IREDELL COUNTY HEALTH DEPARTMENT

IMPROVEMENT PERMIT / AUTHORIZATION TO CONSTRUCT / OPERATION PERMIT / EXISTING SYSTEM INSPECTION

PERMIT# 140257 PIN# 4710290863 DATE 8-15-07

SUBDIVISION HARBOR WATCH BLOCK / SECTION -1- LOT 30 LOT AREA 1.82AC SITE CLASS. PS DESIGN FLOW 480 L.T.A.R. .3

PLOT PLAN

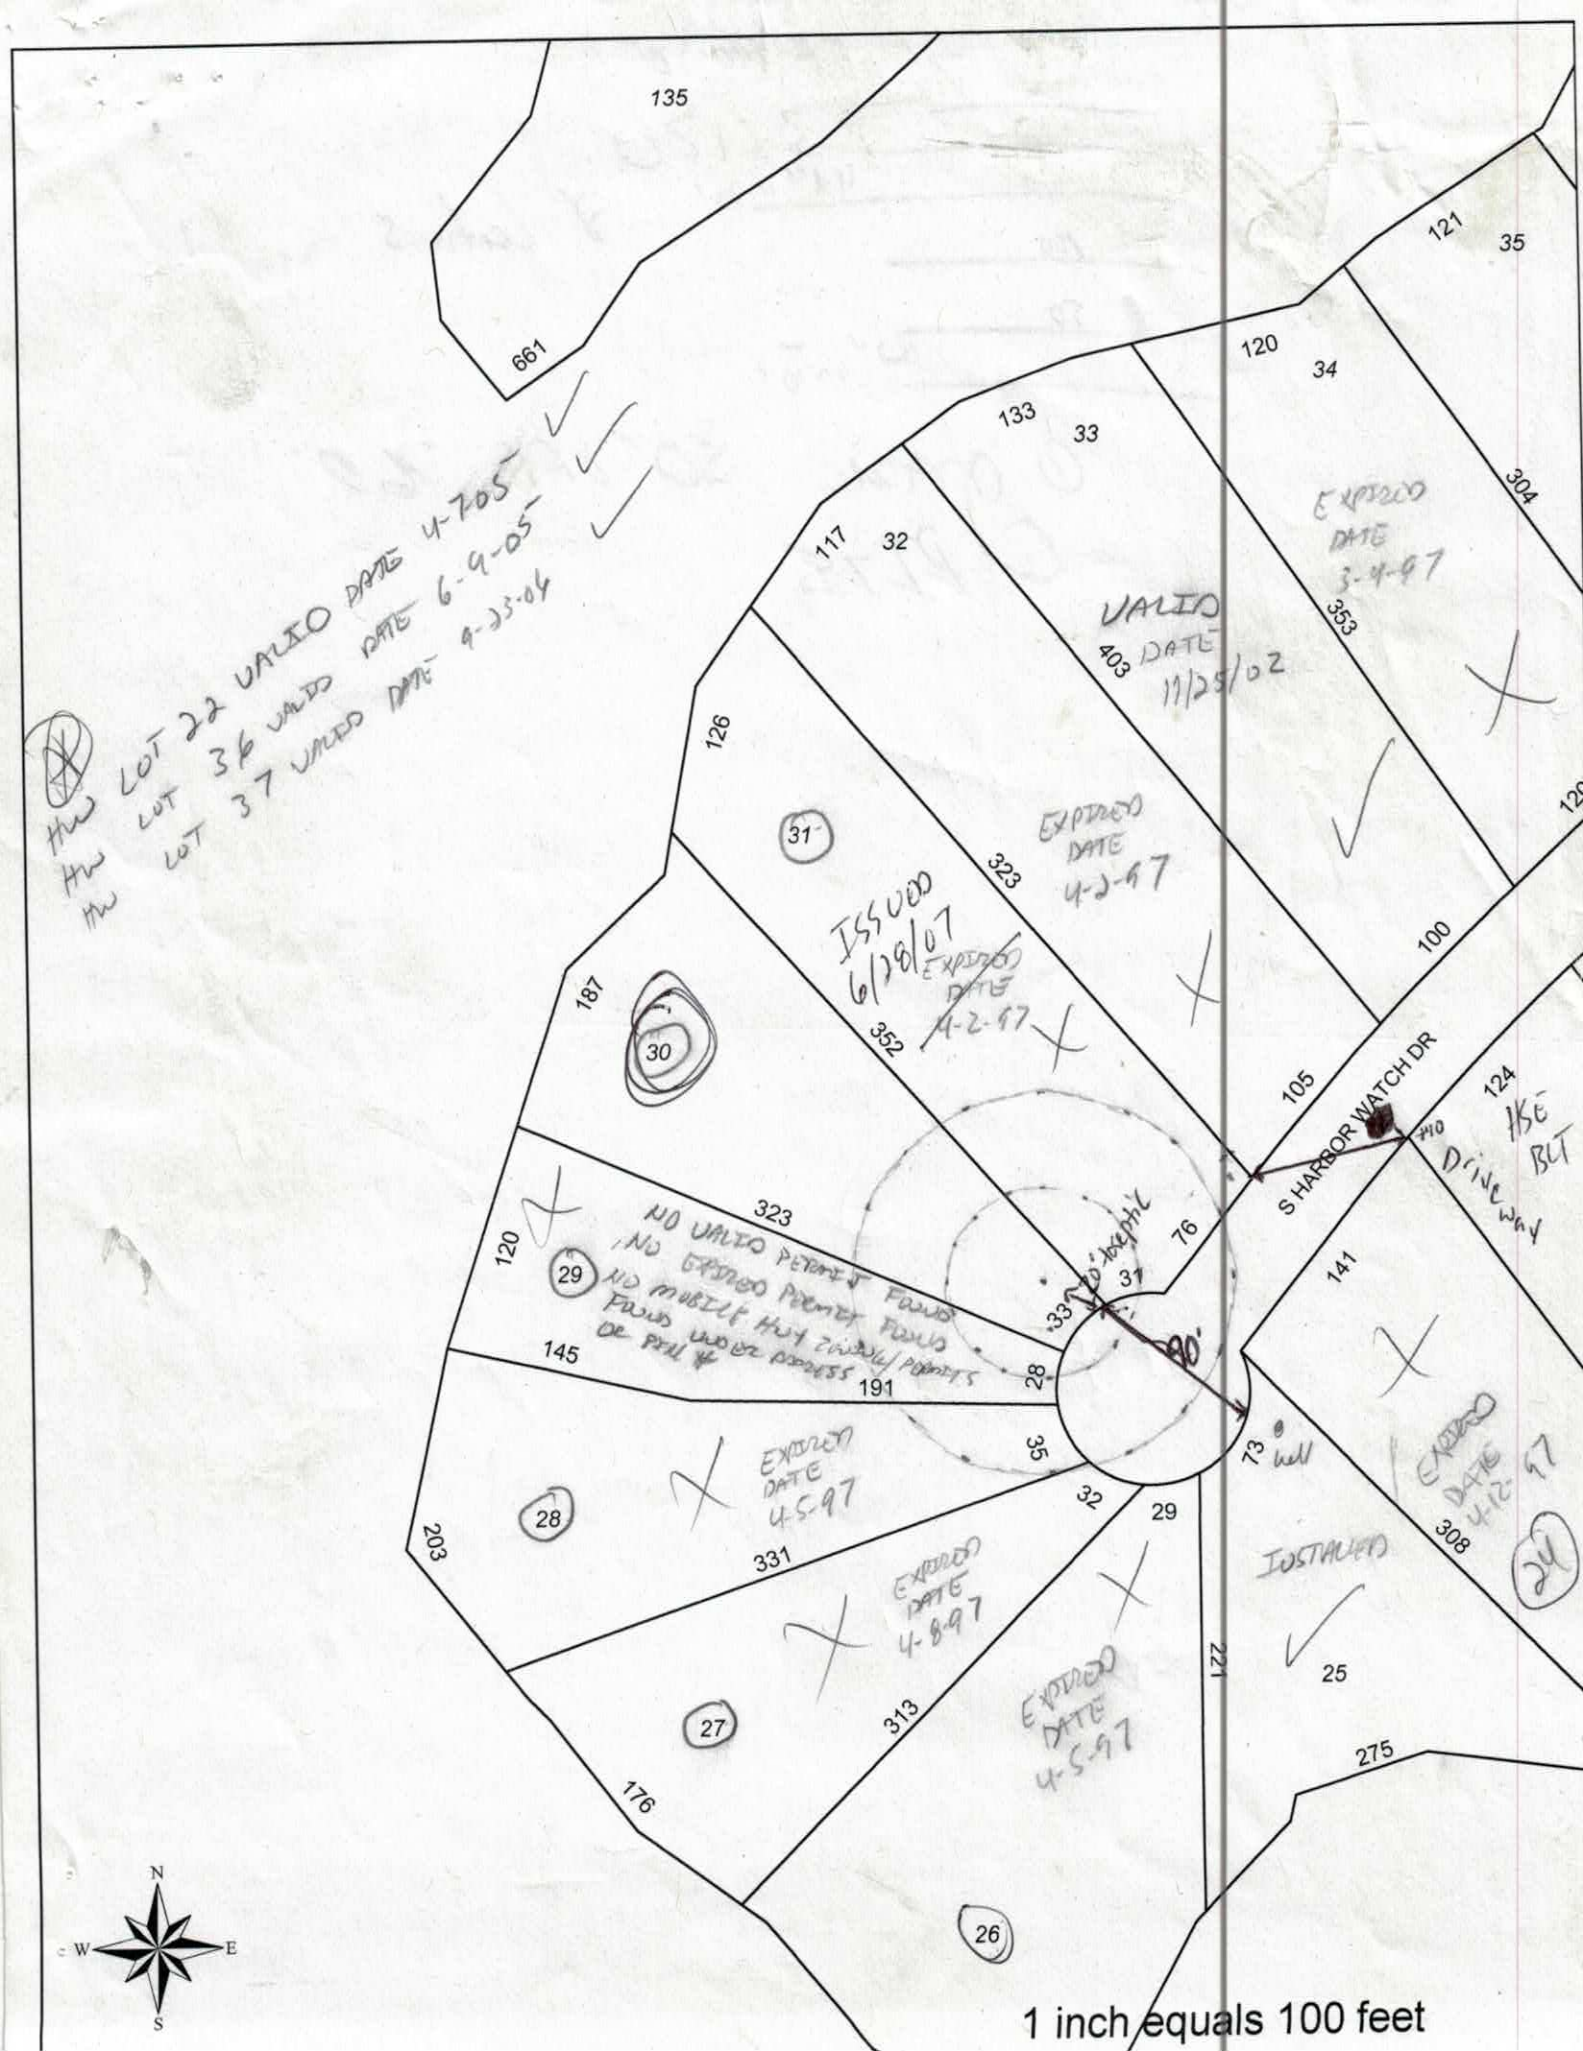
Supply to be installed AT 30" Minimum AND SLEEVE UNDER DRIVE

9/18/07
HAD 155' ON Previous Drawing which was wrong. BUILDER CALLED & IS CHANGED TO 80'. Lane Look Rs.

First Floor Plan

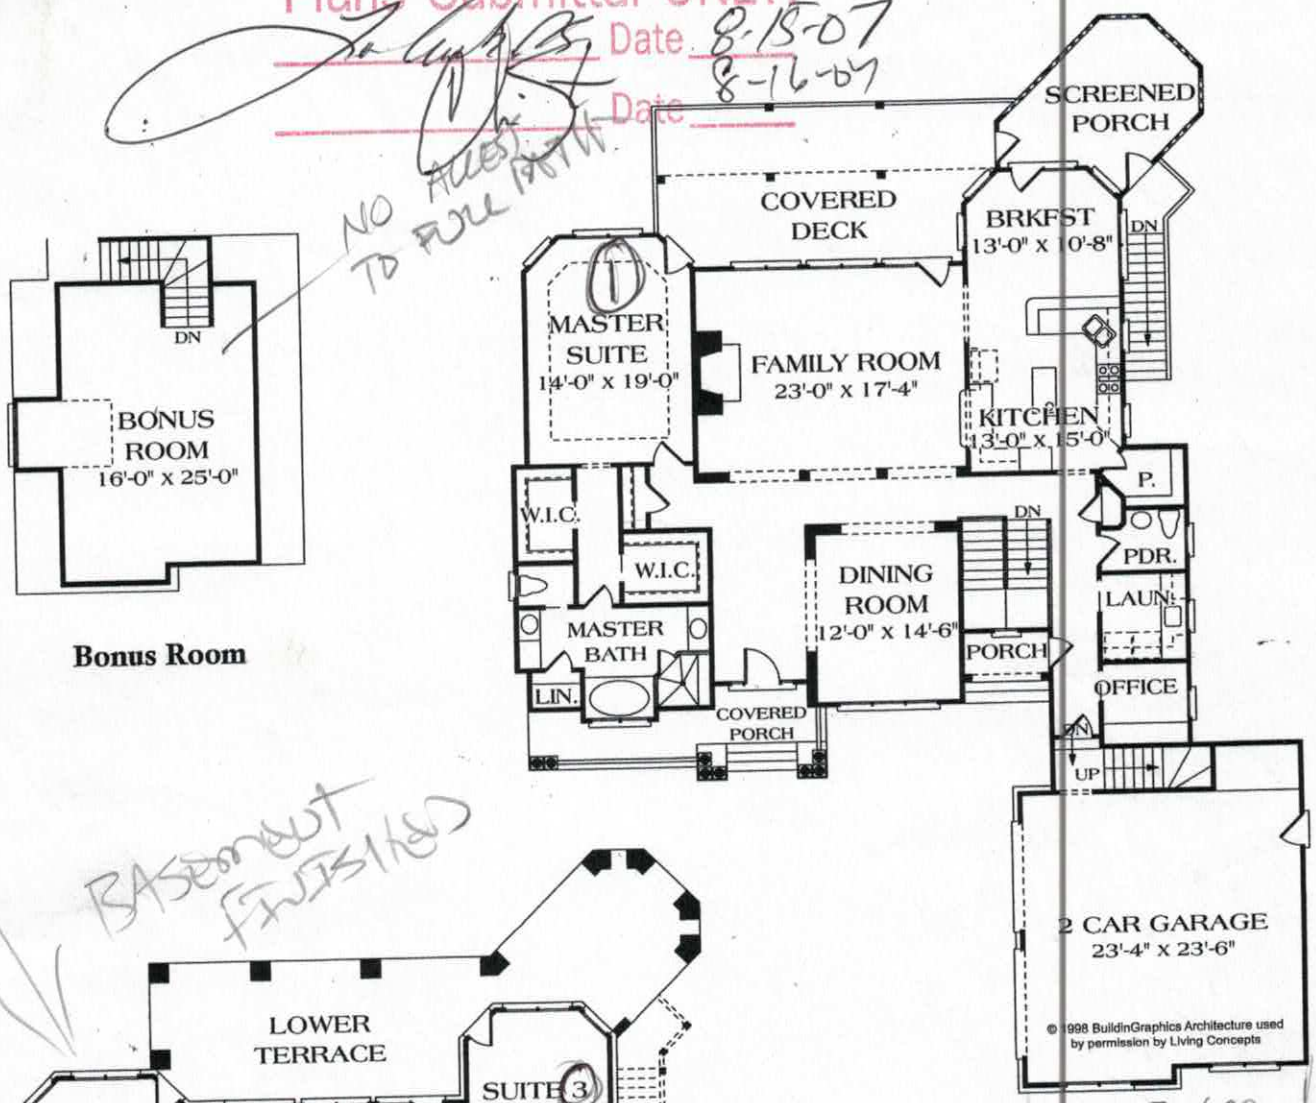
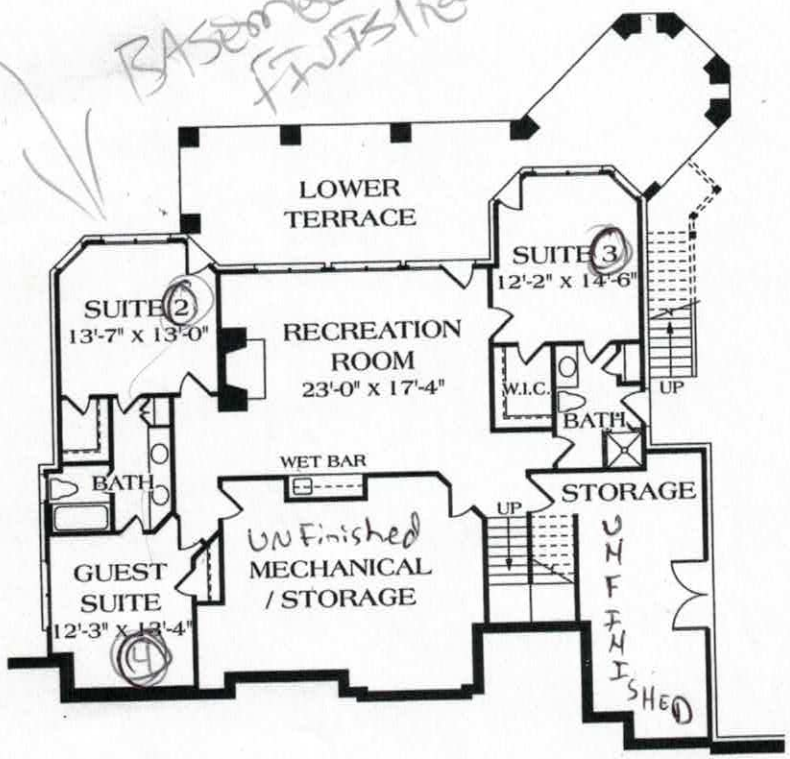
☒ BUILDER CALLED 9-16-07. WANTS TO SLIDE WELL UP & Changed 3 CAR GARAGE TO A 2 CAR GARAGE. EXPLAINED SETBACK From WELL TO SETBACK FROM LAKE 100', THUS 50', Home 25' house will slide up 11' DUE TO 2 CAR GARAGE CHANGE AND Front of Home will be in exactly same place which will not affect the system. Lorne Cook He may get a well variance from DENR TO HAVE WELL CLOSER TO HOME, BUT STILL MAINTAIN TWO OF SETBACKS

3 CAR GARAGE 11' STAIRS ON SITE
